# Access Compliance Report

## Public Rights-of-Way

| Intersection ID: 14003 | Main Street: MT_VERNON_AV | Cross Street: MYRTLE_AV | Location: NW           |
| ADA ID: 175CD337369B   | Ramp Type: BlendTrans2    | Initial Pass/Fail: Fail | Overall Compliance: No |

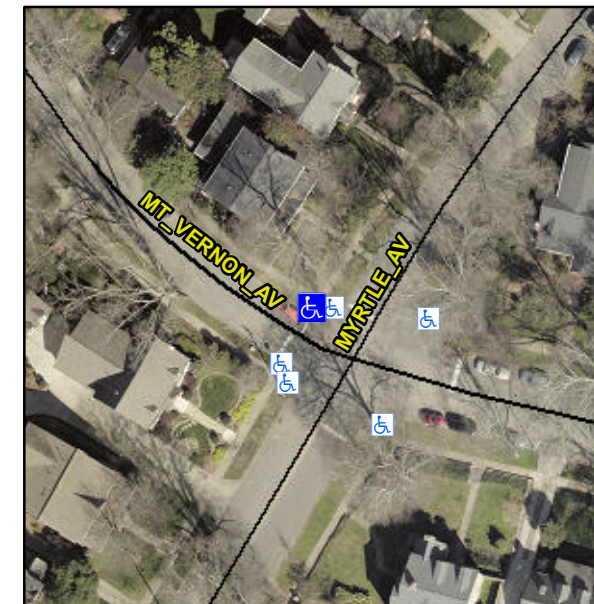
|                        |                           | Severity Score: 1.25    |                        |

**NO LNDG**

**R304.5.3**

| Compliance | Description           | Data | Compliance | Description                 | Data |
|------------|-----------------------|------|------------|-----------------------------|------|
| Yes        | Ramp Width (in)       | 54.0 | No         | BlendTrans XSlope (%)       | 4.1  |

**Remove & Replace Curb Ramp With Two New Directional Ramps or Equivalent.**
